Subject: Service Bulletin 159-036-00, Rev. 0 for Load Cell Torsional Fatigue Failure

Document: 159-036-00

Subject: Load Cell Torsional Fatigue Failure

Applicability: Helicopter models AS350, AS355, EC130, Bell 206L and Bell 407 with an Onboard Systems superseded load cell installed per Table 1.

Figure 1 – Crack initiation site of load cell due to torque loads (210-249-XX). Note: cracks may begin under cover plates and not be observable without disassembly.

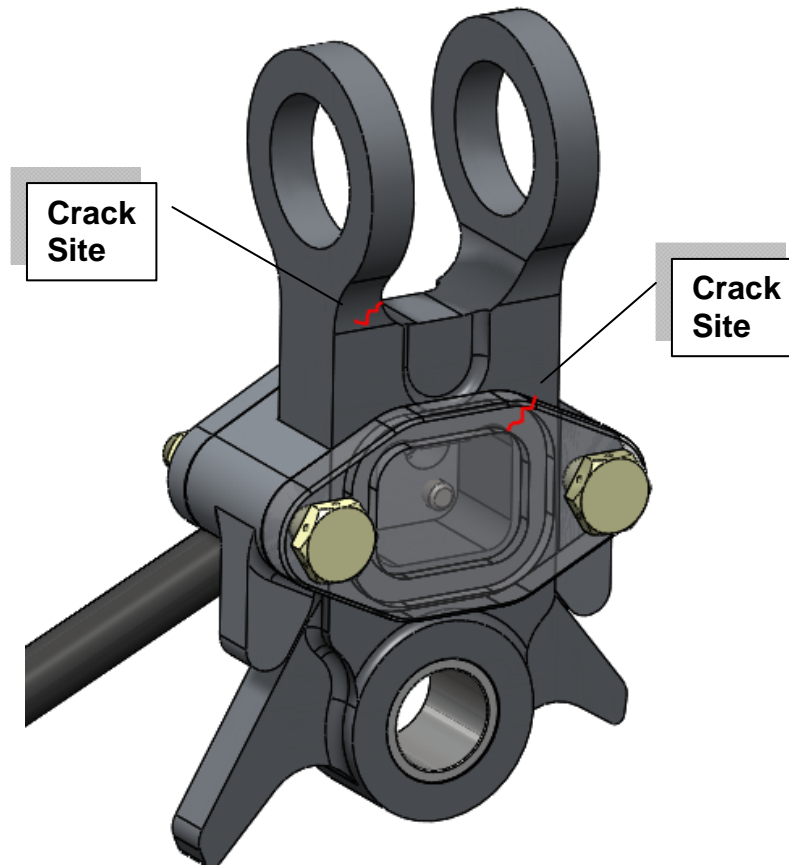
Description: A small number of load cells have been reported to have structurally failed in the field, leading to loss of load. In each instance, investigation has suggested that these failures occurred as a result of repetitive torsional loading, as defined herein. Certain types of external cargo configurations place torsional loads on the cargo hook attachment, including the load cell. Over time, fatigue failure may result.

The superseded load cells called out in this bulletin, when subject to repetitive torsional loads defined herein, may fail suddenly—resulting in load separation, loss of equipment and injury / death of ground crew.

Solution: Several Onboard Systems load cells have been redesigned to better accommodate torsional loads. If torsional loading is a part of your helicopter operations (as defined herein), it is recommended that that you upgrade to the latest configuration as expeditiously as possible. If torsional loading is *not* part of your helicopter operations, it is recommended to upgrade at time of next overhaul.

- (1) Inspect your equipment to determine what part number configuration load cell is present on your aircraft. If you already have the 'replacement load cell', no further action is required. If part number marking is missing, contact Onboard Systems for assistance. If you have a superseded load cell installed, continue below.

- (2) If torsional loading is present per the **Torsional Load Description** definition on page 3, limit external load time to 100 hours between overhaul of the load cell. Upgrade the load cell to the latest configuration as soon as possible. Remove and replace the load cell per the applicable Instructions for Continued Airworthiness manual. Time between overhaul then returns to the period defined in the applicable documentation (see Publications Affected).
